Elevating and Amusement Devices Safety Division	Ref. No.: 271 / 18
DIRECTOR'S ORDER	Date: September 17, 2018

Re: Requirements for B355 Vertical Platform Lifts that utilize Magnetic Reed Switches in Leveling and/or Anti-creep Circuits

Drawing 1: SPDT Reed switch design: When glass reed breaks, short occurs across both sets of contacts and shorts out door lock circuit, moving the lift with the door open. This can occur in both the up or down levelling circuit.

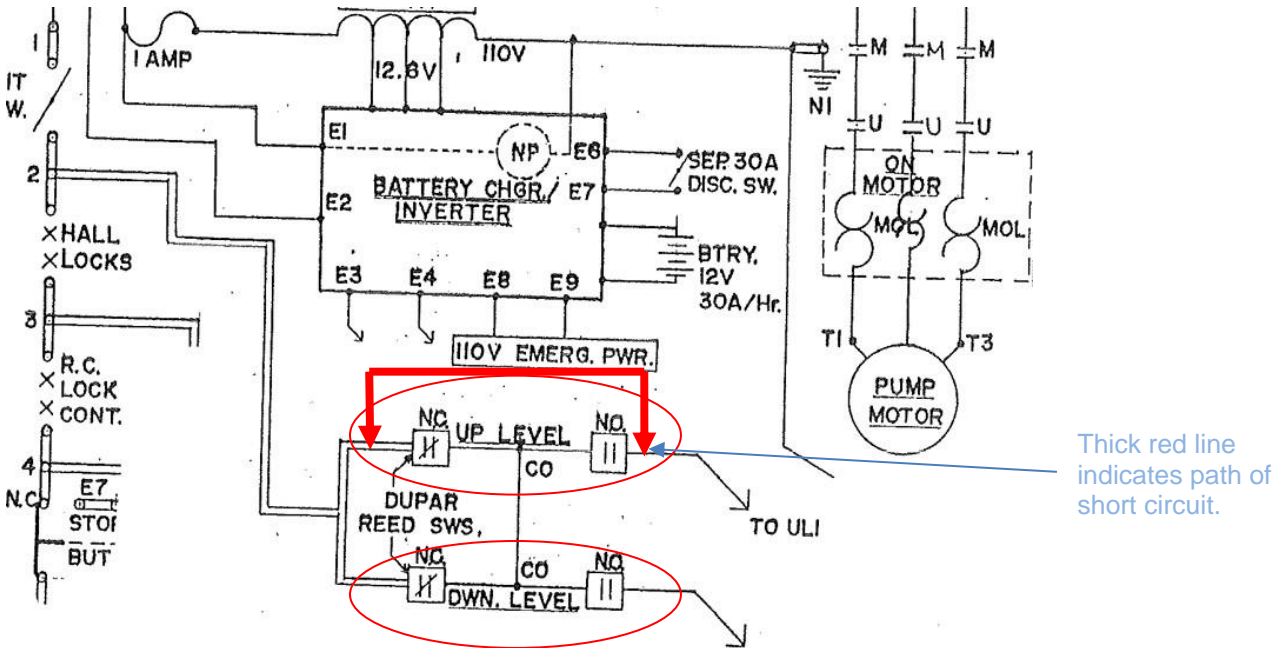
Drawing 2: SPDT Reed switch design: When glass reed breaks, short occurs across both sets of contacts and shorts out door lock circuit, moving the lift with the door open. This can occur in both the up or down levelling circuit.
